UNITED STATES PATENT AND TRADEMARK OFFICE

APPLICATION NO.	FILING DATE	FIRST NAMED INVENTOR	ATTORNEY DOCKET NO.	CONFIRMATION NO.
10/765,636	01/27/2004	Gerald R. Savicki JR.	905P164	2271

Office Action Summary

DETAILED ACTION

FIG. 5

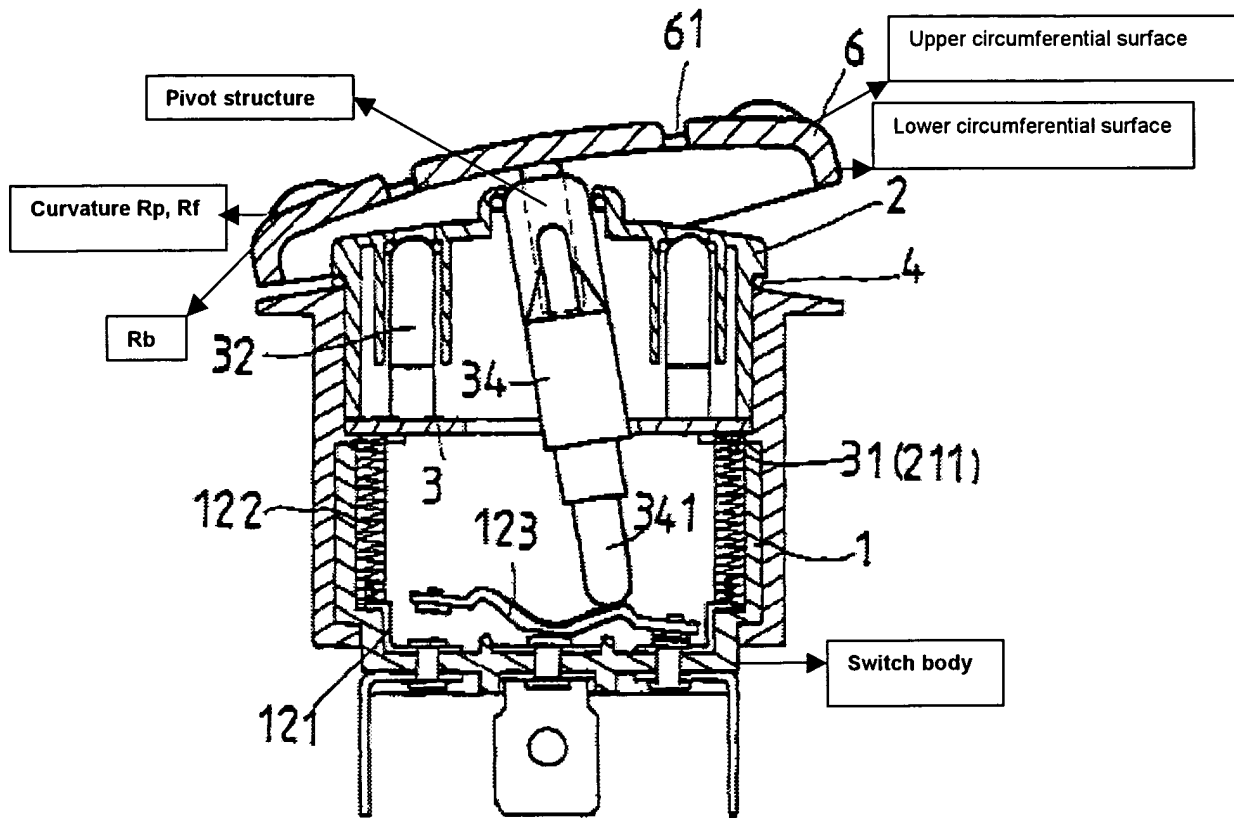
- a switch body 1 including switch contact (see attachment);
- a frame 5 attached to the switch body;
- a paddle 6 for actuating the switch contacts;
- wherein the paddle has a pivot structure cooperatively engageable with a portion of the frame for selective rotational movement around a pivot axis (see the attachment) between a limited forwardly-tilted position and a limited rearwardly-tilted position;
- wherein the paddle has a uni-convex cylindrical exterior surface with a curvature, R_p (see the attachment);
- the paddle 6 has an actuating structure integrally attached to a rear surface thereof having a distal end that operationally enables an open-switch condition and a closed-switch condition;
- the paddle 6 has an upper and a lower circumferential surface (see the attachment) each having a curvature, R_b , the center of which originates along the pivot axis;

Yei further comprises the paddle 6 includes an upper and a lower circumferential surface having a curvature, Rb (see the attachment), the center of which originates along the pivot axis.

FIG. 5

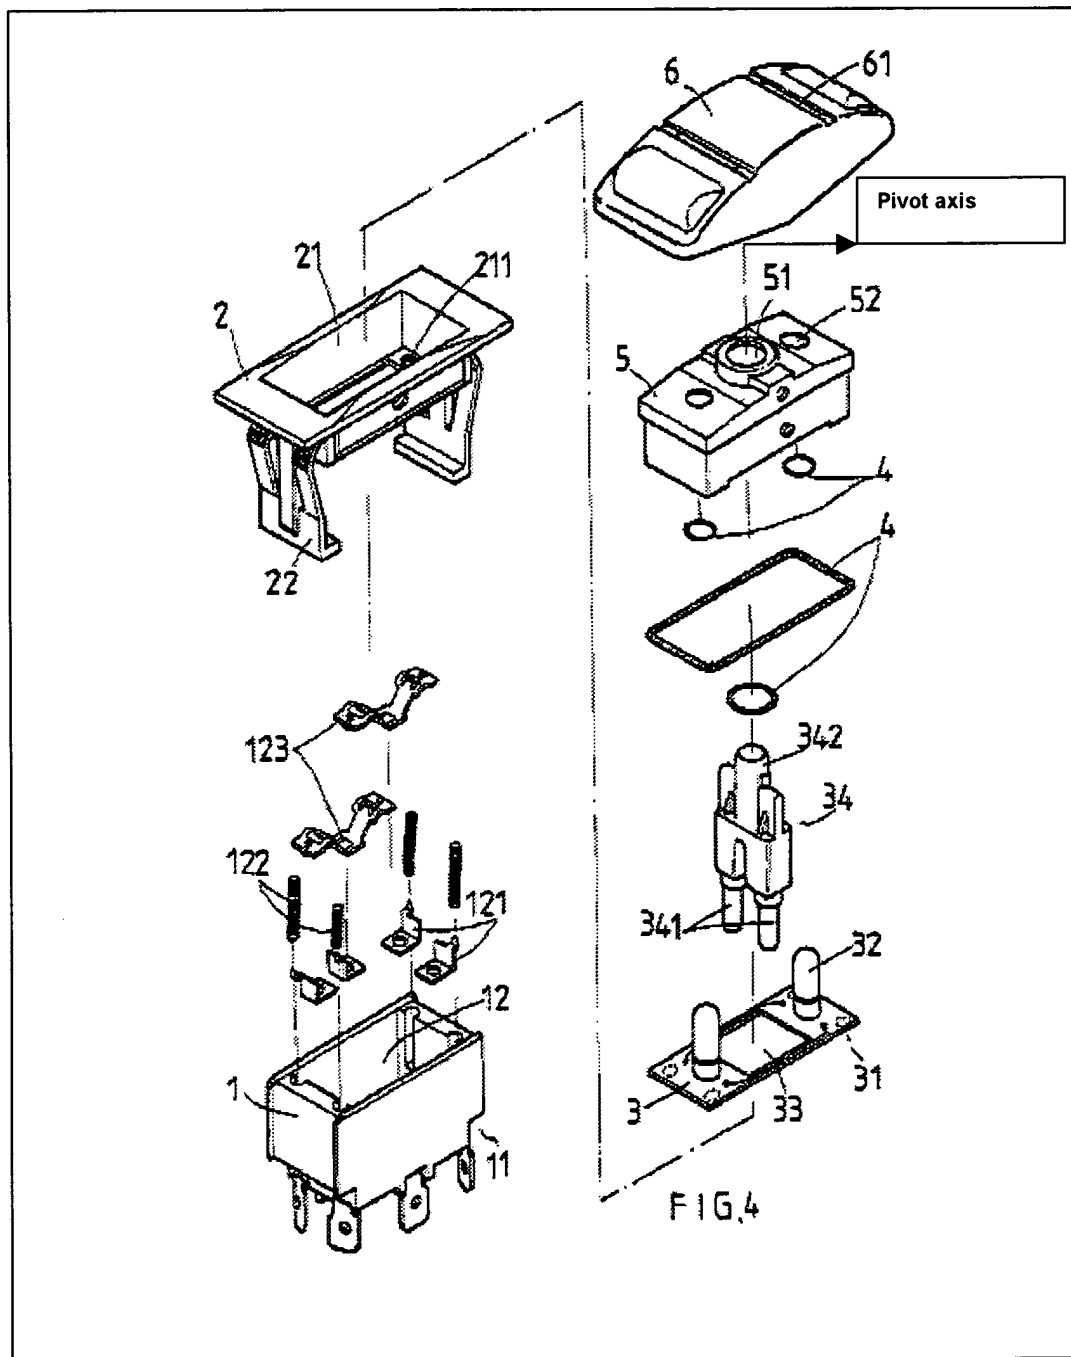
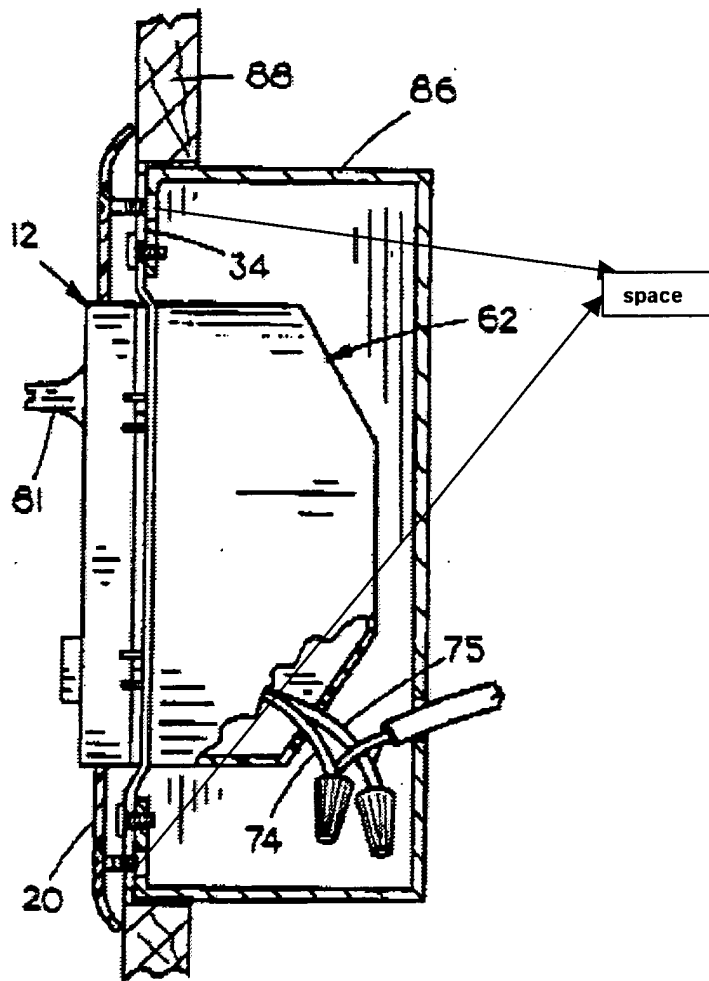
- a mounting strap 34 attached to the switch body 62;
- one of the upper and the lower circumferential surfaces 20 engages a space (see the attachment) intermediate a portion of the mounting strap 34 and a surface of the frame 86 in one of the forwardly-tilted position and the rearwardly-tilted position;
